## **Determination 2008/103**

### **Safety barriers for a swimming pool at 25 Picton Street, Auckland**

**Figure1: The swimming pool as detailed in the building consent application**

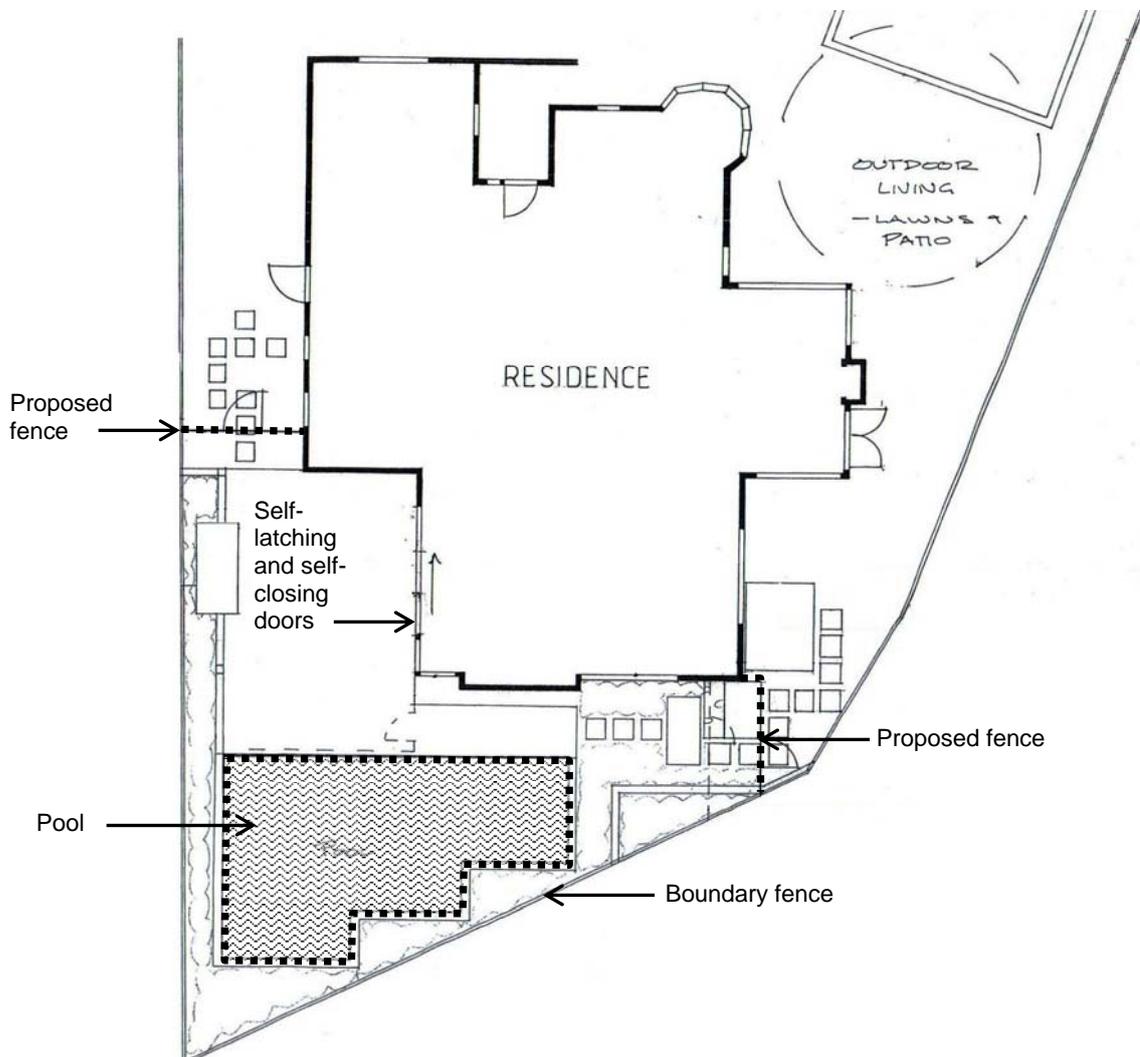
- had concerns regarding the view of the pool from the house
- noted that the bi-fold doors did not open directly onto the pool
- did not accept that bi-fold doors could be fully self-closing and accordingly, this solution still raised doubts
- could only approve an amendment with a pool fence running from the south east corner of the house.

4.3 In a submission to the Department dated 11 August 2008, the authority noted that the applicants had modified their proposal to change the existing bi-fold doors into self-closing ranch-sliders and had proposed that a pool alarm be installed. The authority was of the opinion that, as the house doors were not facing the pool, the revised additional area could not be considered as being an “immediate pool area”. In addition, the restrictive window area facing the pool area would significantly obstruct the visual supervision of children using the pool area.

- 7.7 The authority have stated that the “issue is the house doors are not facing the pool”, which meant that the enclosed area cannot be considered as being “the immediate pool area”. The authority also notes that “the restrictive window area directly facing the pool” would obstruct the supervision of children. However, neither clauses 8 to 11 of the Schedule nor the definition in section 2 of the Fencing of Swimming Pool Act refers to the location of doors opening onto a pool area. In addition, there is nothing in the latter Act that refers to visual supervision of children from the house (see paragraph 7.4).

- 7.8 Based on the observations made in paragraphs 7.2 to 7.7, I conclude that the fenced area under the proposed amendment can properly be called “the immediate pool area”.

8.3 Based on the information that I have received, I conclude that the doors, if installed as the applicants have described, will comply with the Building Code.

9.1 For the reasons set out above I conclude that the proposed amendment to the building consent, including the revised sliding doors, complies with the Building Code. I must therefore reverse the territorial authority’s decision to refuse to issue the amendment.
